DATAFILE BULLETIN

FILE UNDER: Receivers
 ER-41-C

Equipment: 132—174 MHz MASTR Progress Line 5-watt receivers

Purpose: **TO OFFER A FIELD MODIFICATION TO REPLACE THE AUDIO OUTPUT
 TRANSISTORS FROM 19A115948-P1 (no longer available) to
 19A116203-P2**

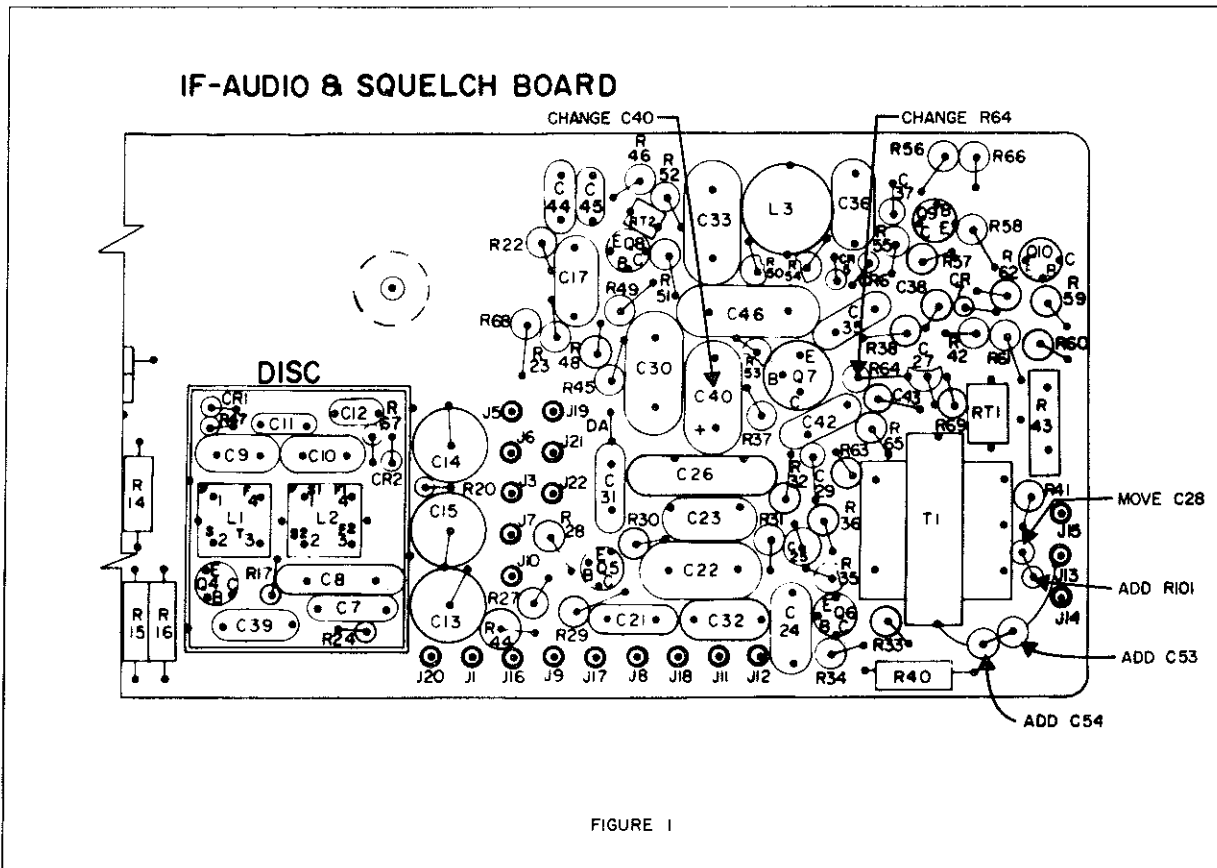
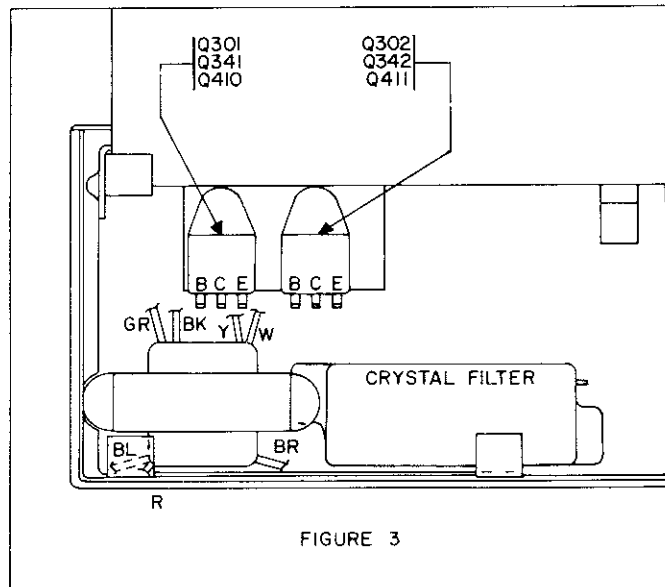
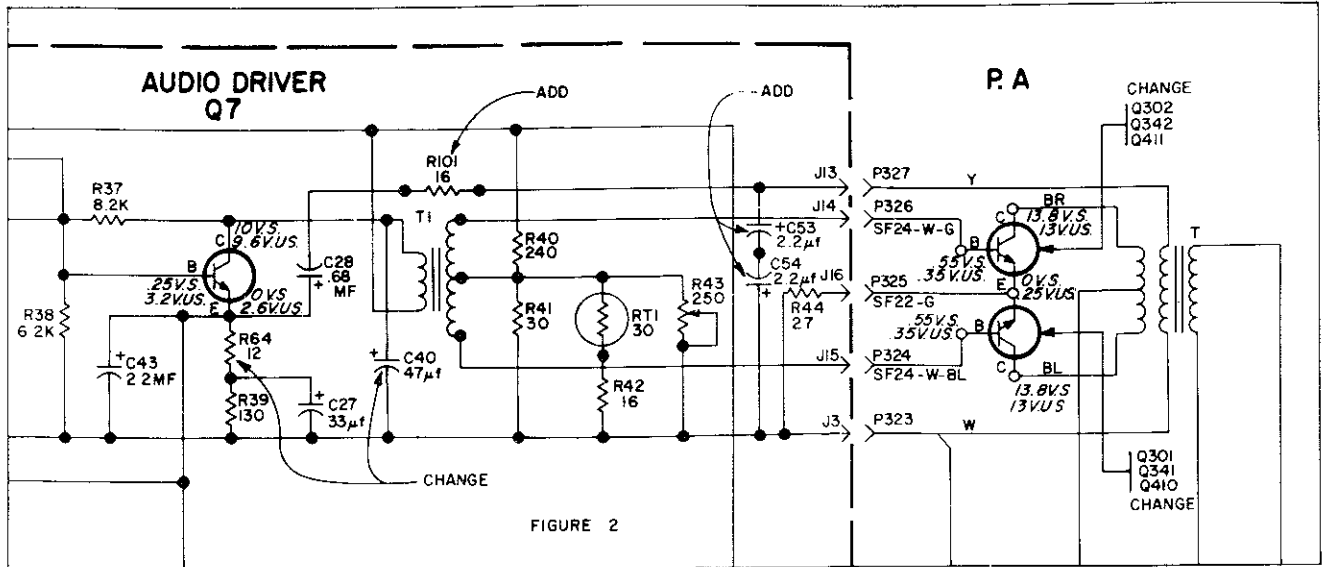
Field Change: The 19A116203-P2 transistor can be used in place of the
 19A115948-P1 but the following changes have to be made:
 (Refer to Figure 1, 2, & 3)

1. Change R64 from 18 ohms to 12 ohms.
2. Change C40 from 0.22 μ F to 0.47 μ F.
3. Add C53 and C54 (2.2 μ F) in series. Solder the can (Neg.) sides together. Connect the positive side of C53 to J13 pad and the positive side of C54 to system negative near T1.
4. Unsolder and carefully remove C28 (0.68 μ F). Solder the positive (+) side of C28 in the pad that connects to C43 & R64.
5. Solder one side of R101 (16 ohms) to the pad connecting J13. Solder the other side of R101 to the negative (-) side of C28.
6. Replace the two audio output transistors with 19A116203-P2. (see Fig. 3) Mount each transistor with a 19A116023-P2 insulator plate and a 19A116022-P1 bushing. Use silicon grease on both sides of the insulator plate.

The lead connections are different from the 19A115948-P1 transistor.

7. TEST PROCEDURE CHANGE: Turn the squelch control fully counterclockwise. Connect a milliammeter in series with the +12 volt lead at P443-11. With no signal in, adjust the PA bias adjust (R43) for a reading of approximately 20 milliamps.
